**STAGE 1 & 2
WORKPLANS**
Amended

From: Hack Conder [hconder@riceswd.com]
Sent: Tuesday, February 03, 2009 6:36 PM
To: Hansen, Edward J., EMNRD
Cc: 'Marvin Burrows'; 'Katie Jones'
Subject: AP ~~48~~⁵⁸ Addendum Section 7.2

From: Gil Van Deventer [mailto:gilbertvandeventer@suddenlink.net]
Sent: Friday, September 26, 2008 2:06 PM
To: Hansen, Edward J., EMNRD
Cc: Chris Williams; Marvin Burrows; Haskell Conder
Subject: BD Santa Rita EOL Release Site (AP-58) - modification to Amended Stage 2 Abatement Plan

AMENDED STAGE 1 & 2 ABATEMENT PLAN (AP-58)

FIGURE 2

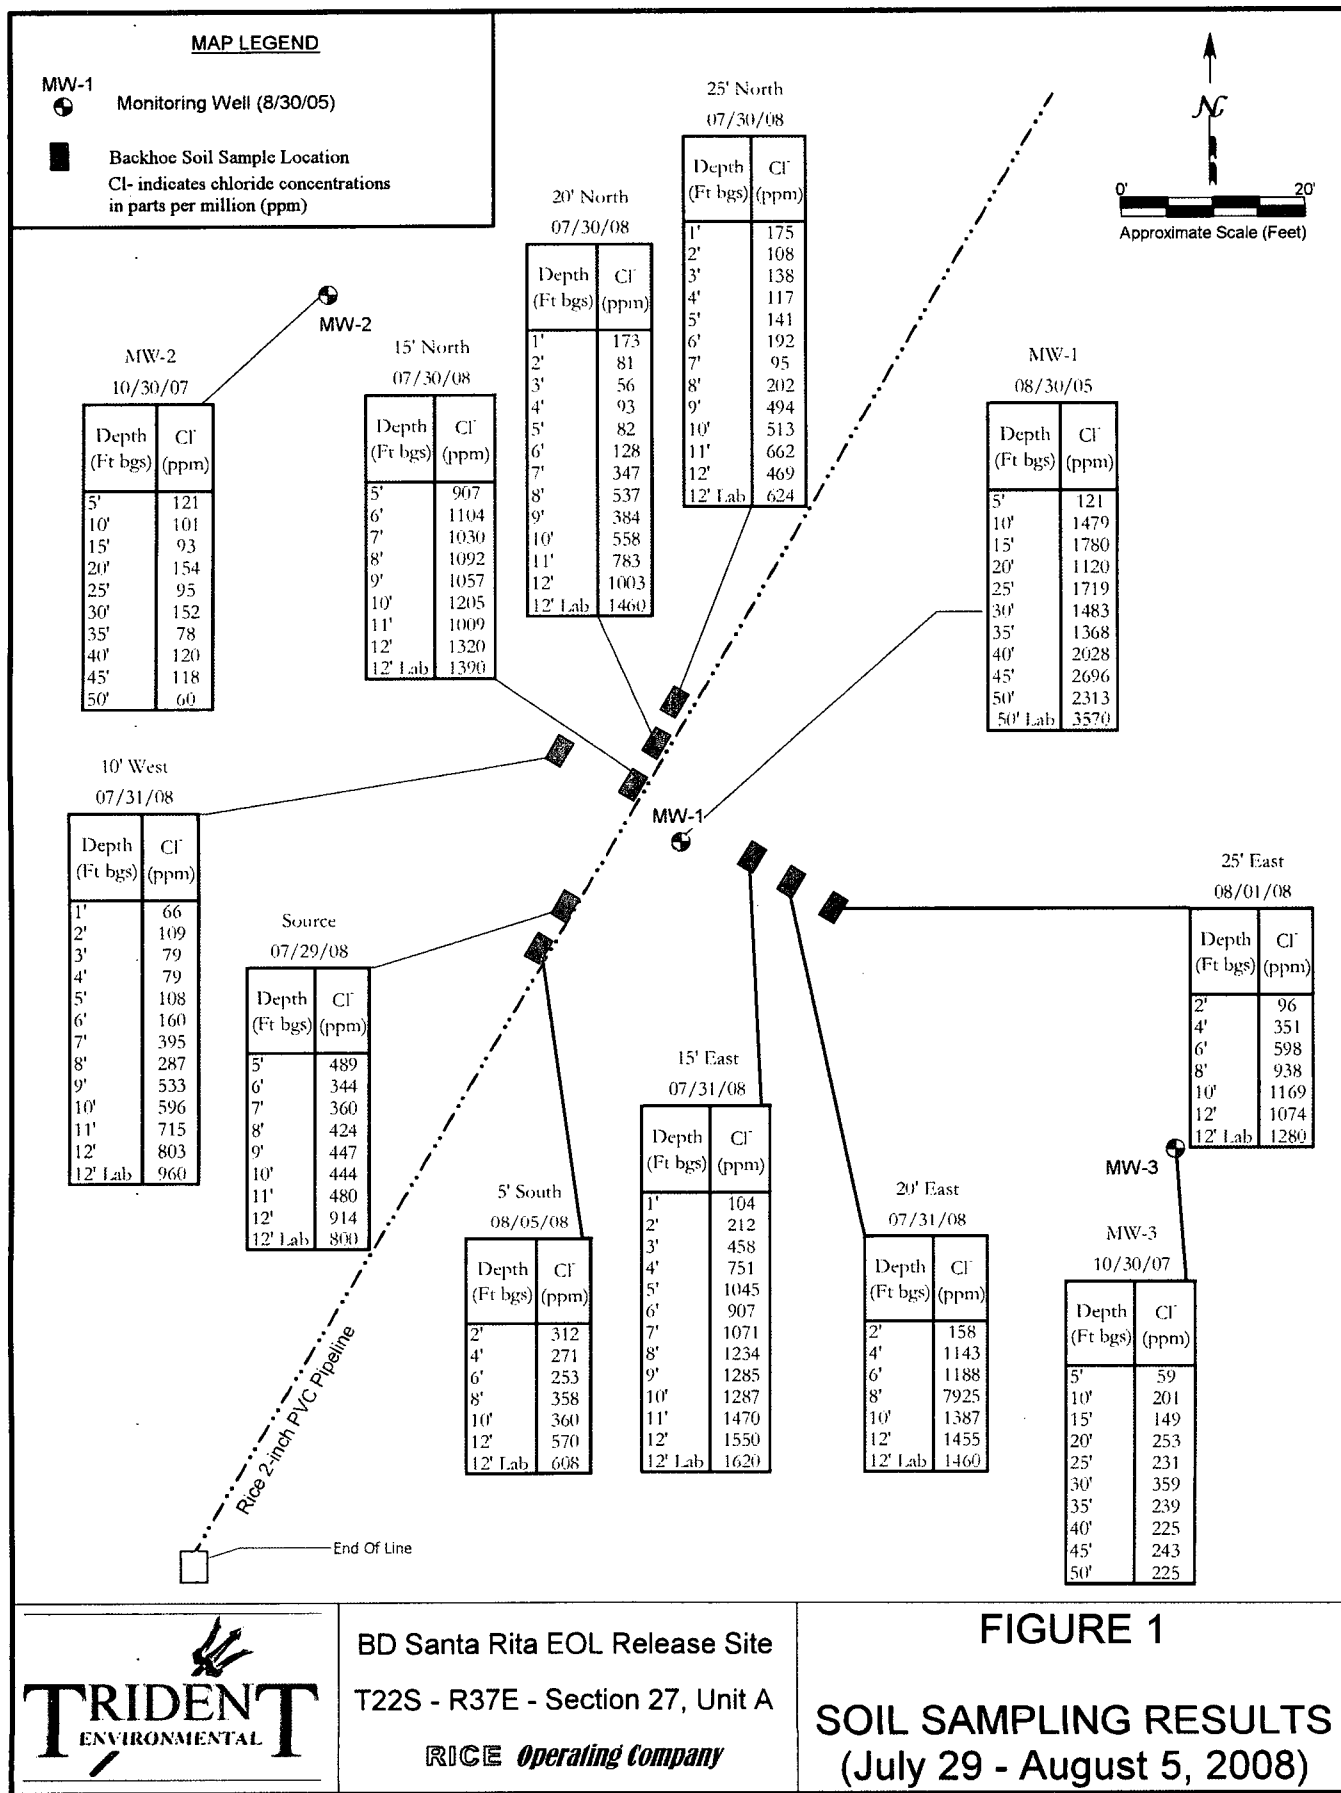
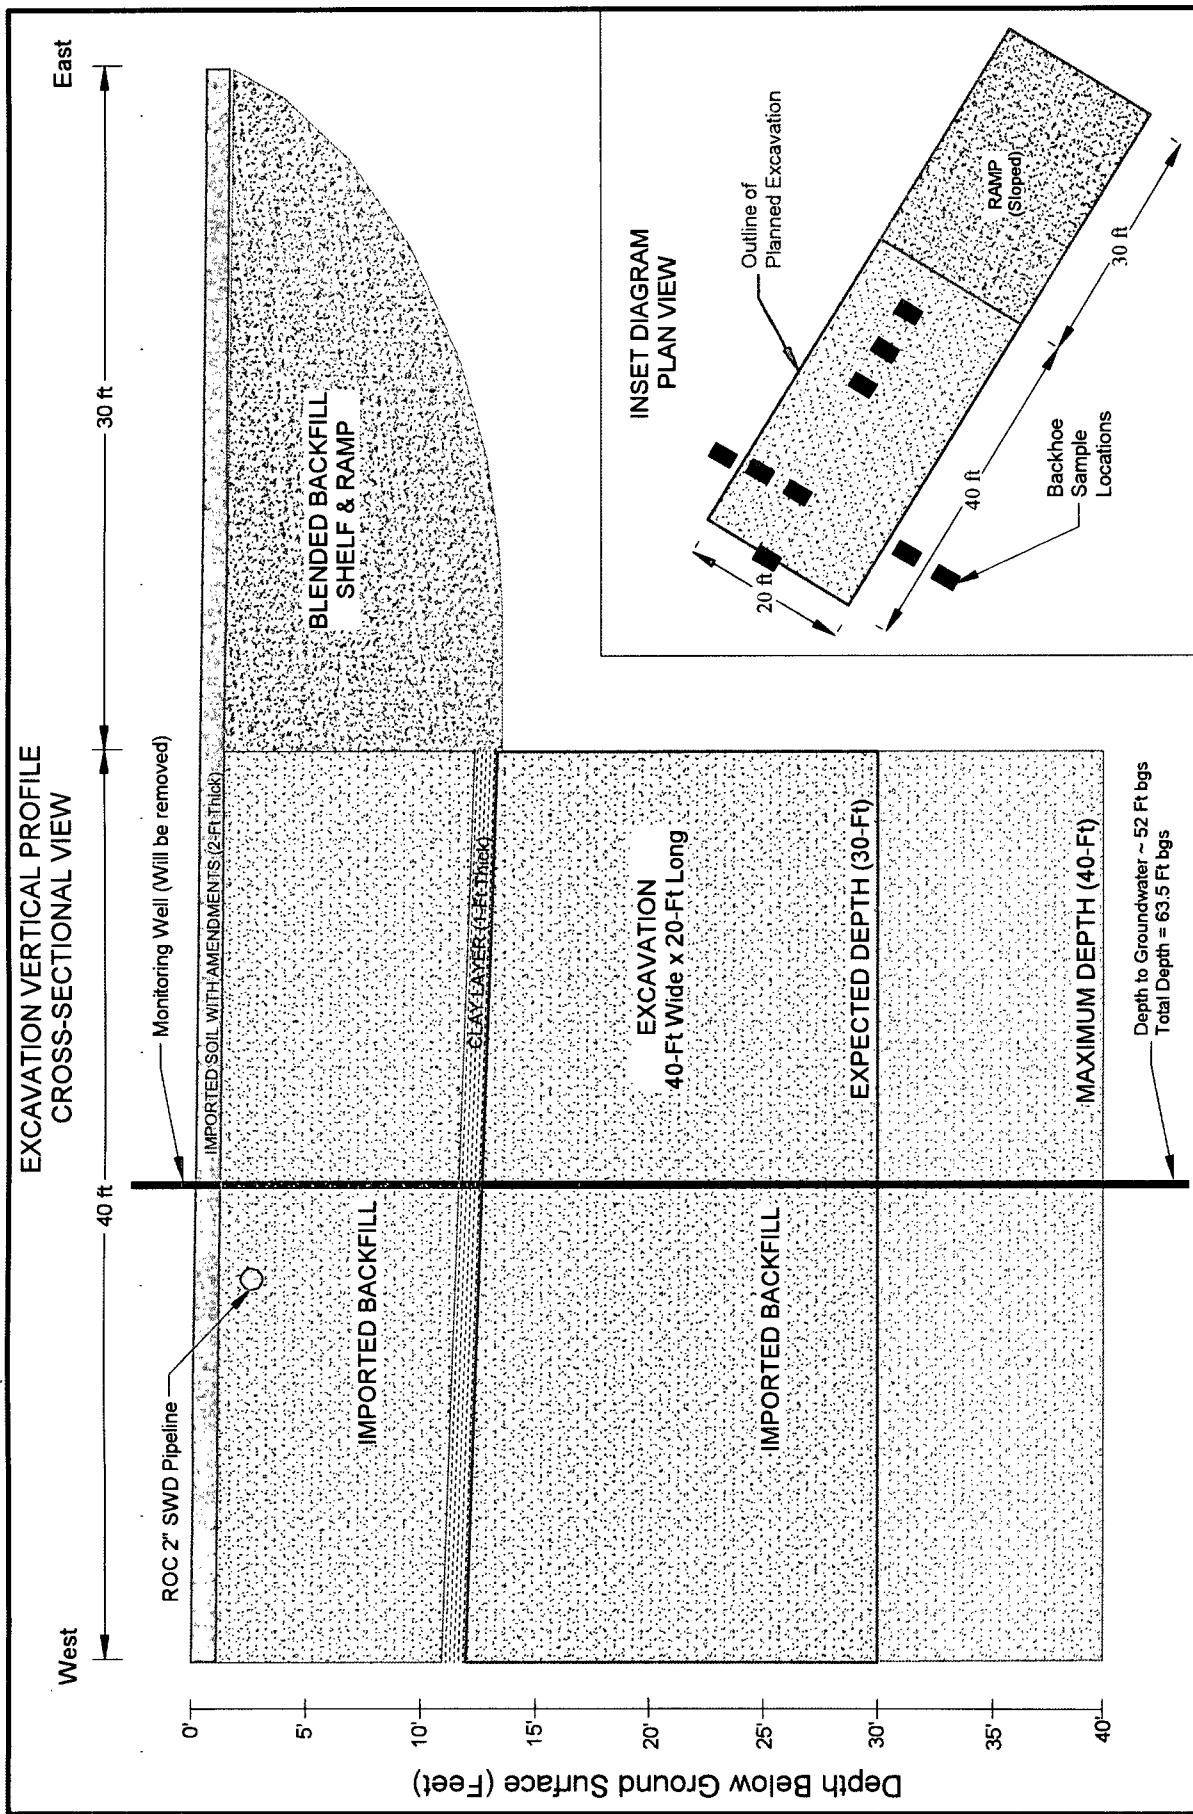
Below is the modification to section 7.1 (*Corrective Action to the Vadose Zone*) of the *Amended Stage 2 Abatement Plan* (section 7.0) for the BD Santa Rita EOL Release Site (AP-58). This modified section is based on verbal agreements made by and between Rice Operating Company (ROC) and the landowner. A Soil Sample Map (Figure 1) and Excavation and Backfill Plan (Figure 2) are attached as well.

Remediation of the vadose zone will be conducted by excavation, backfilling, and installation of a clay layer in the vicinity of the actual leak as further delineated (chloride field testing) during recent backhoe sampling between July 29, 2008 and August 5, 2008. Results of the recent sampling activities and those conducted during the installation of the monitoring wells are shown on the attached site map (Figure 1). The excavation will extend 40 ft wide by 20 ft long. The excavation will proceed to an expected depth of 30 feet below ground surface (ft bgs) and a maximum depth of 40 ft bgs dependent on confirmation of declining chloride concentrations with depth. A 20 ft wide by 30 ft long access ramp will also be utilized for access by heavy equipment. The excavation will be backfilled with imported soil up to a depth of 12 ft bgs followed by a one-ft thick clay layer which will be laid to a grade that will direct any infiltrated precipitation away from the spill area. Additional imported soil will then be used to backfill over the clay layer to a depth of 2 ft bgs. The ramped area will be backfilled with blended soil such that chloride concentrations are less than 500 mg/kg. A final 2-ft thick layer of imported topsoil will be placed above the final backfill layer such that a slight mound is constructed to direct excess precipitation from the spill area. Native grass seed will be broadcast for re-vegetation, and the site will be monitored for plant growth. The goal will be to re-vegetate the site to approximately 70% of the ground cover as observed in adjacent areas not affected by the release. Figure 2 depicts a cross-section (vertical profile) and plan view of the excavation and backfill plan.

No modifications to section 7.2 (Corrective Action to the Groundwater) are anticipated with the exception of the necessary removal of monitoring well MW-1 during the course of excavation. The well will be plugged and abandoned in accordance with NMOSE requirements. Replacement of MW-1 is not necessary because chloride and TDS levels in MW-1 have

steadily declined and stabilized to near background concentrations. Furthermore, monitoring well MW-3 now serves as the most impacted monitoring point and is nearest to the center of chloride mass in groundwater.

The entire section of the ROC 2-inch SWD pipeline (PVC and A/C) has been replaced with 4-inch poly line.
